CONSTRUCTION SUMMARY

Lindsay 2017 Developments Inc. / Sugarwood

Lot/Unit: 142 Block 87 Phase/Building: 1 Model/Floor Plan: Sturgeon Lake(2006)Elev B End 4Bed 2.5Bath

Sugar usood
Skutch # |

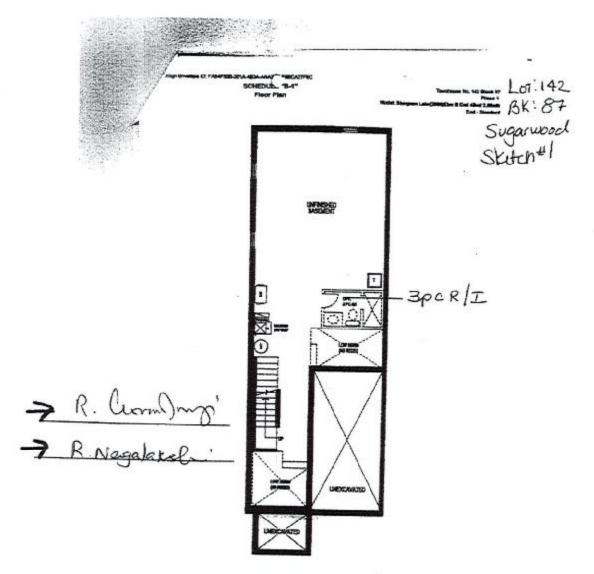
Inv. 5463	1 - To supply and install the 3 piece rough in in the unfinished basement see sketch # 1	
Line 70273	Note:	
16Mar22 / 16Mar22
